Re: Edgewater proposal

Review of the Madison Comprehensive Plan as it relates to the Edgewater redevelopment proposal.

Commentary on Edgewater UDC 1/20/10 and 2/3/10 Submissions and Handout

Subject: Edgewater Hotel Redevelopment

PARKING RAMP ENTRANCE ILLUSTRATION

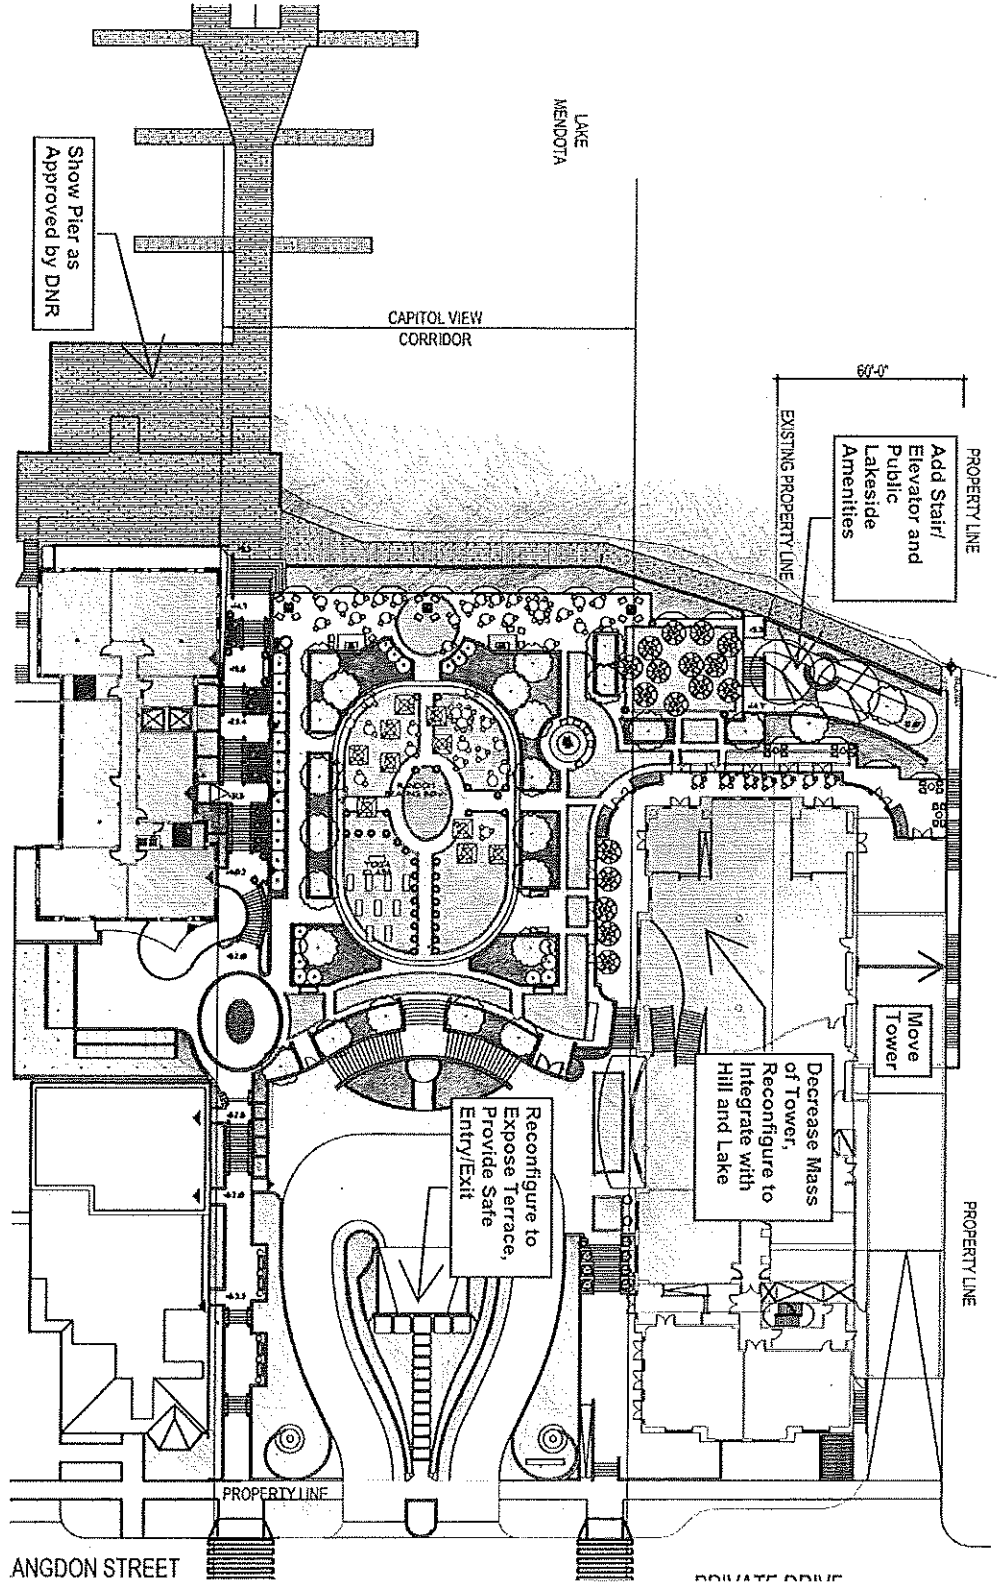
The current configuration of the entrance to the parking ramp creates a significant bottleneck. All traffic entering and leaving the parking ramp across each other's pathway at a critical stage in the and maneuvering area. Visibility of vehicles leaving the ramp is especially impaired. *The auto court needs reconfiguration.* (see "PARKING RAMP ENTRANCE ILLUSTRATION" at the end of this document)

Wisconsin Avenue Facade Comparison @ 1" = 30'
 The Masonic Temple - Quisling Towers
 December 9, 2009

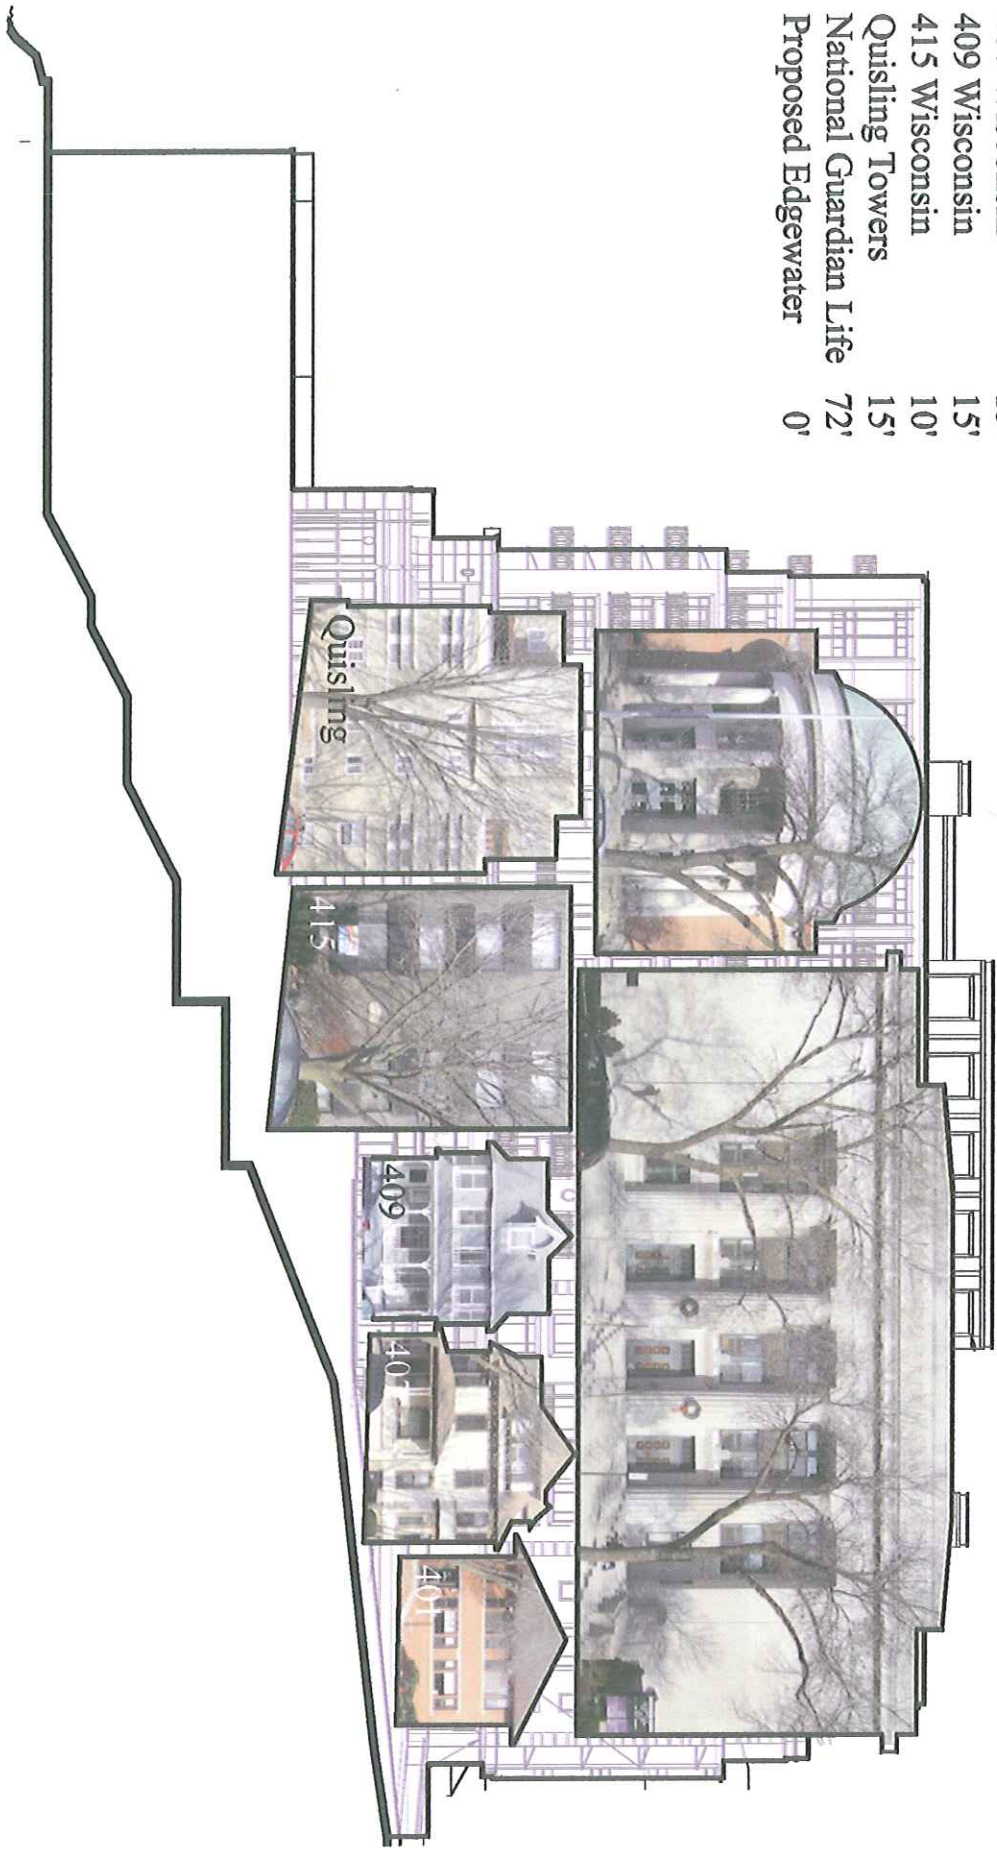
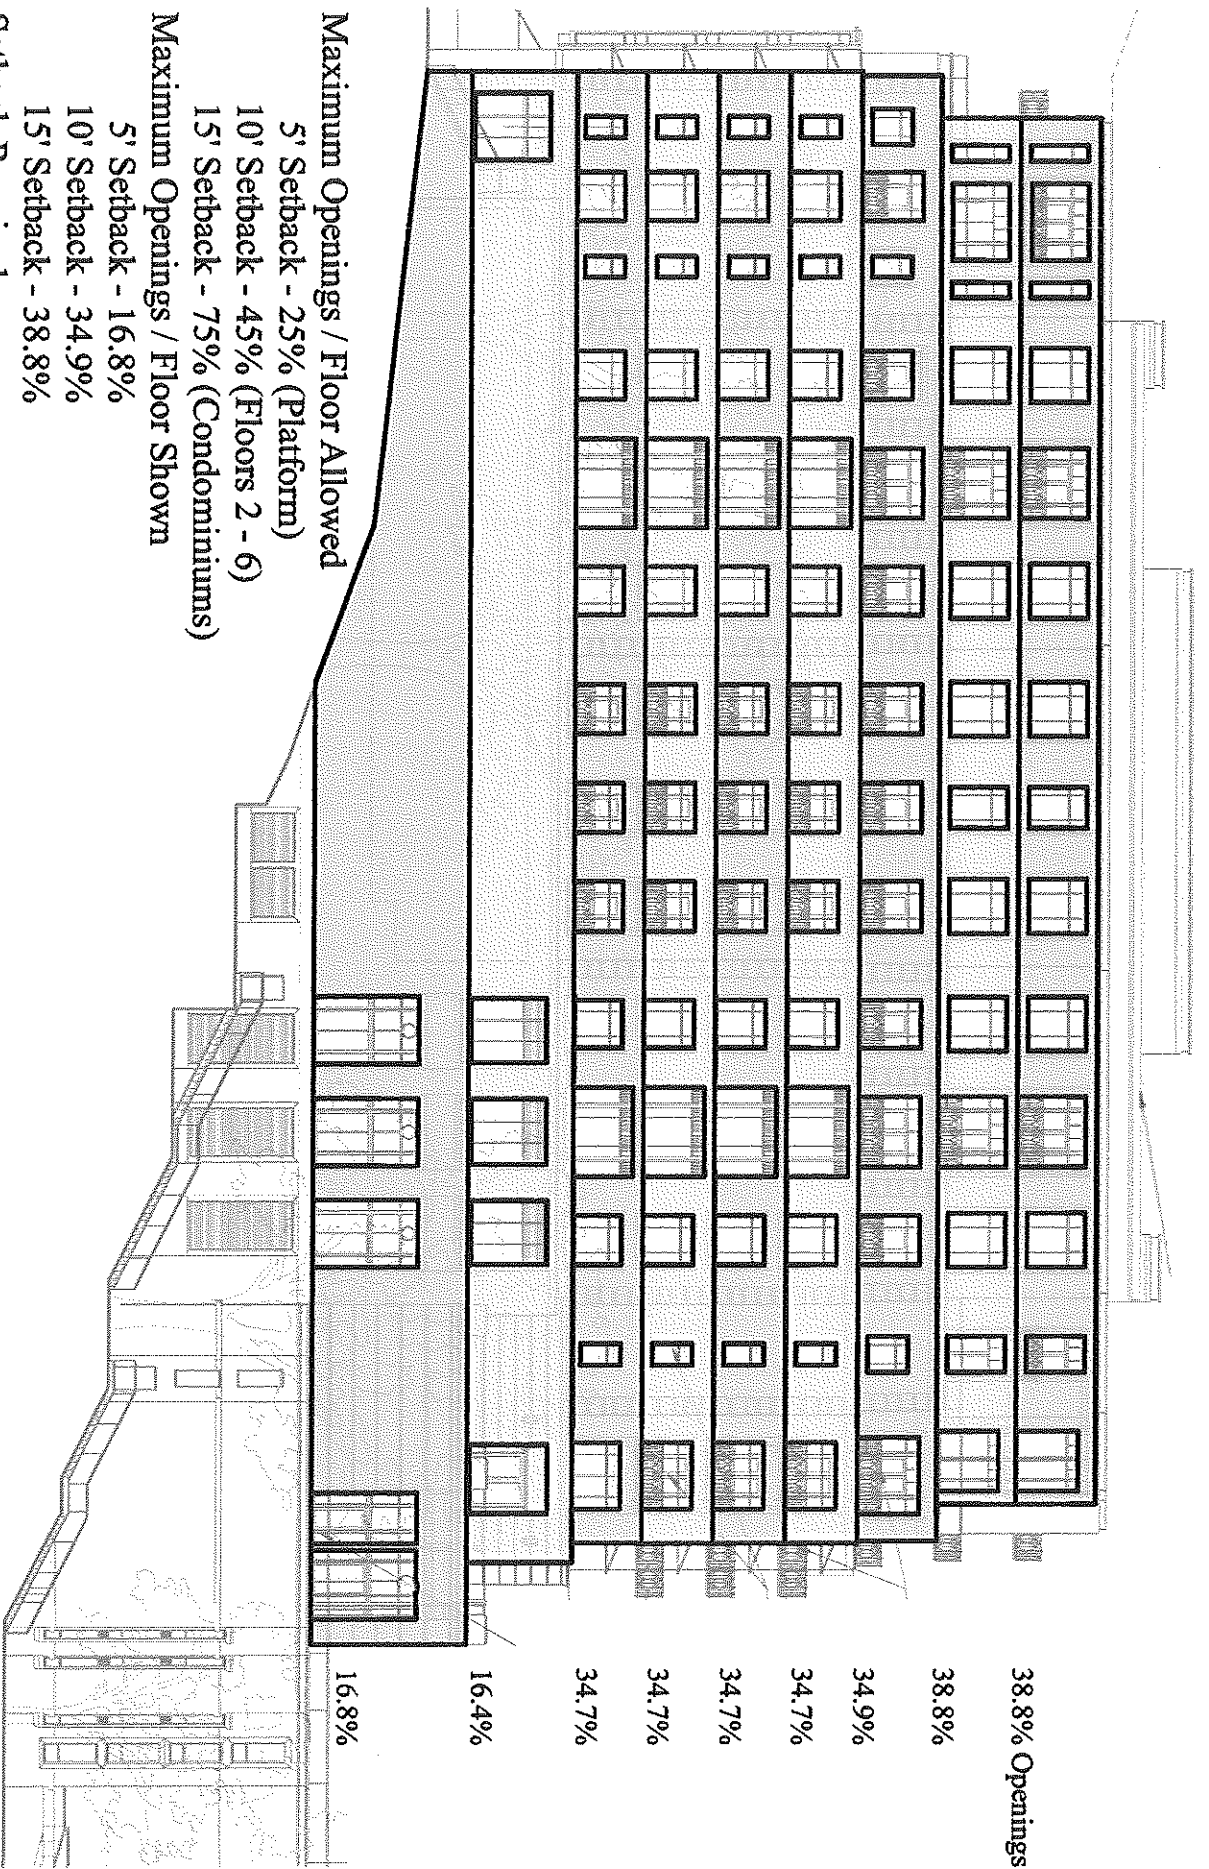
| Wisconsin Avenue Setbacks | |
|---------------------------|-----|
| Proposed Edgewater | 0' |

- 5' Setback - 16.8%
- 10' Setback - 34.9%
- 15' Setback - 38.8%

Setback Required

- Platform - 5'
- Tower - 10'
